Date:	8 December 2022	Contact name:	Greg Britton
Your reference:		Telephone:	+61 2 8854 5000
Our reference:	8A0132_L005.F01-response	Email:	greg.britton@rhdhv.com

**PPSSTH-176 – SHELLHARBOUR – DA0276/2021 – COVE BOULEVARD, SHELL COVE -  
PRECINCT H SUBDIVISION  
Response to Comments from Southern Regional Planning Panel**

Figure 1 2125 coastal hazard zones (ZSA and ZRFC) for SSP2-4.5 (Intermediate)

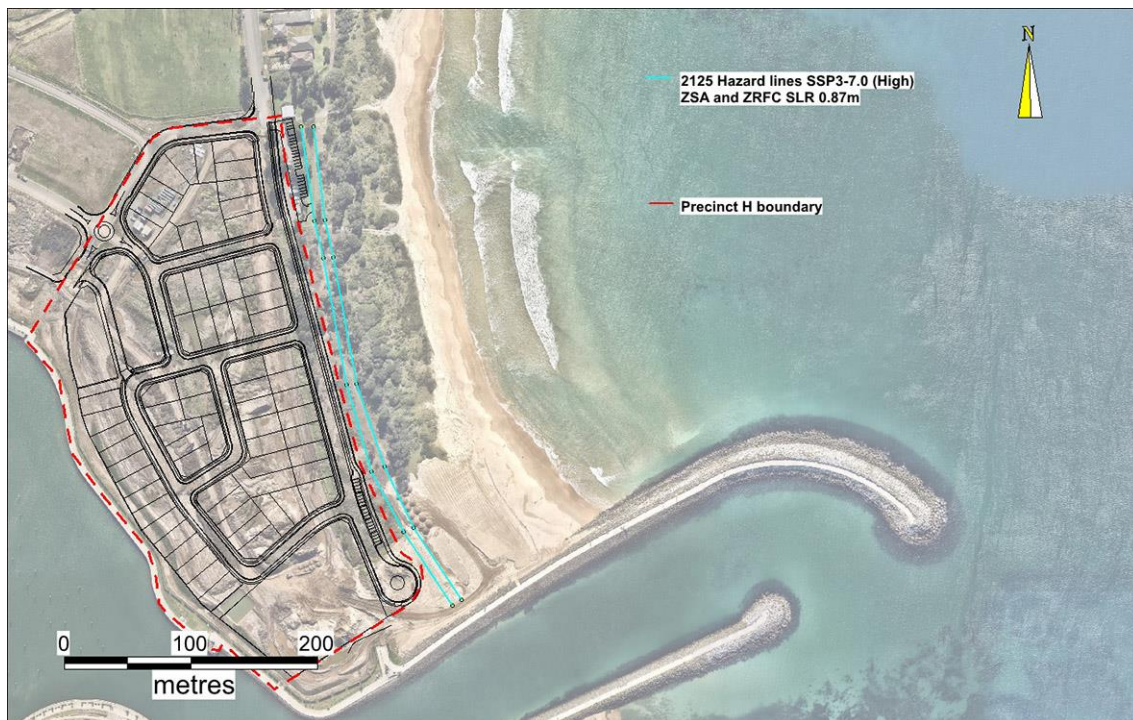
**Comment 1 – The potential extent of coastal hazards over a minimum 100-year timeframe (ie. to 2123), consistent with guidance in the NSW Coastal Management Manual 2018, as referenced by the *Coastal Management Act 2016*.**

The calculated 2125 hazard zones (ZSA and ZRFC) for scenarios SSP2-4.5 (Intermediate), SSP3-7.0 (High) and SSP5-8.5 (Very High) are shown in Figures 1, 2 and 3 respectively. The ZRFC is the landward of the two zones, as depicted in Figure 4 under the response to Comment 5.

The location of the ZRFC for sea level rise scenario SSP5-8.5 (Very High) relative to the carparks is not considered to be of concern since it is very unlikely this scenario would represent the world's climate future, having regard to the existing national policies and expected future policies regarding fossil fuels and renewable energy, ie. the assumptions underlying the scenario (refer Table 1) are very unlikely to prevail in practice.

Figure 4 Ortho-rectified aerial photography 2012 to 2020 (source Nearmap). Red line shows shoreline, vegetation, breakwater and groyne as at June 2020

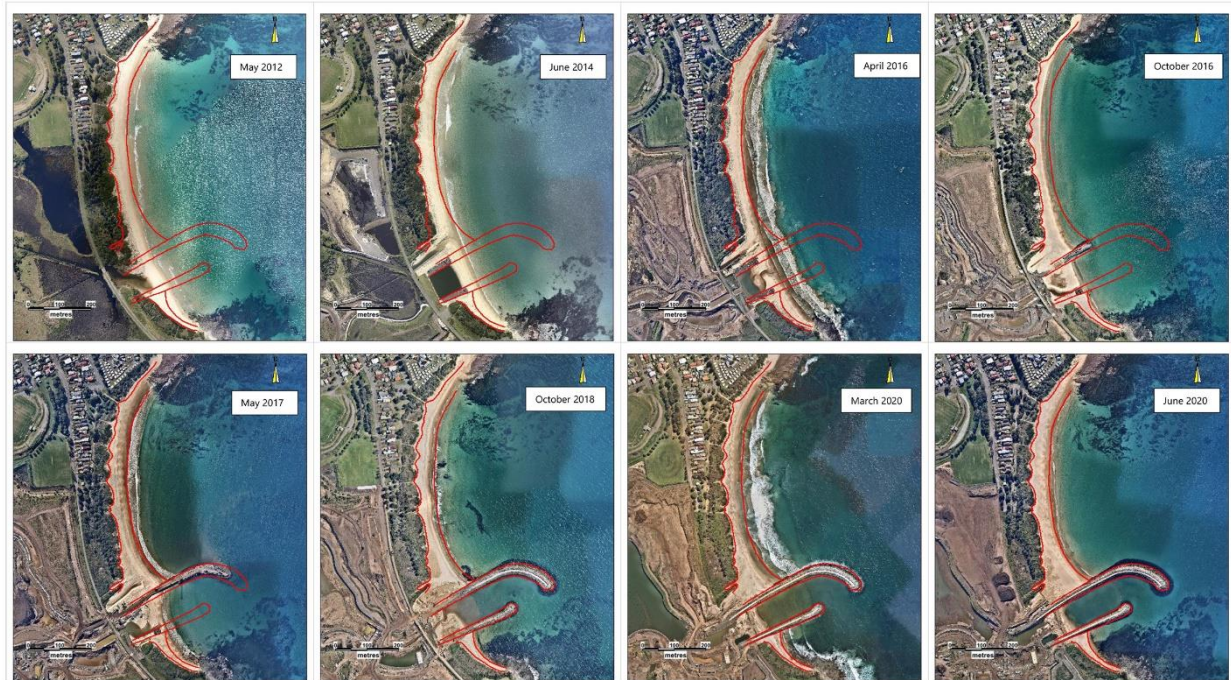
**Comment 3 – The effects of the recently constructed breakwaters on wave transformation and sediment transport processes particularly regarding the likely location of coastal risk zones at current and future timeframes.**

Figure 4 taken from Advisian (2020) shows ortho-rectified vertical aerial images of the beach over a series of dates from May 2012 (prior to breakwater and groyne construction) to June 2020 (after breakwater and groyne completion) together with the outline of the breakwater and groyne, foreshore vegetation, and beach shoreline, as at June 2020 (all in red). The sequence of images shows the evolution of the beach planform in response to the breakwater construction, together with the beach response to storms, eg. the East Coast Low in February 2020.

The breakwater and groyne structures have altered sediment transport processes at the southern end of Shellharbour South Beach, leading to changes in the beach planform for example. These changes are evident in the series of vertical aerial images in Figure 4. The beach to the north of the breakwater and the beach to the south of the groyne are essentially now separate coastal compartments.

The changes in sediment transport processes leading to beach planform change have been accounted for in the assessment of the likely location of the coastal risk zones, as outlined above.

Figure 5 Methodology for calculation of coastal hazard zones in Nielsen et al (1992)

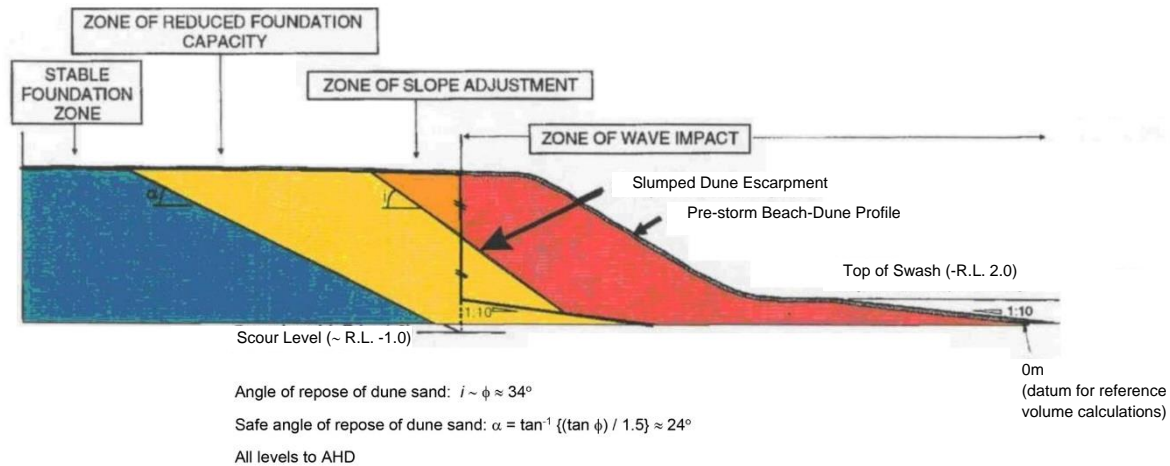
**Comment 5 – The calculation of the expected zone of reduced foundation capacity (extending landward) taken from the proposed dune height of 5.5m.**

The expected zone of reduced foundation capacity (ZRFC) has been calculated according to the methodology set out in Nielsen et al (1992), shown in Figure 5. This is standard practice in NSW coastal hazard assessment.

Nielsen et al (1992) proposed a natural angle of repose of the dune sand ( $\phi$ ) equal to 34° and a Factor of Safety (FOS) of 1.5 for calculation of the ZRFC. A slightly lesser value for  $\phi$  of 33° has been adopted in the determination of the coastal hazards outlined in this response, which is slightly conservative. A FOS of 1.5 has been adopted consistent with Nielsen et al (1992).
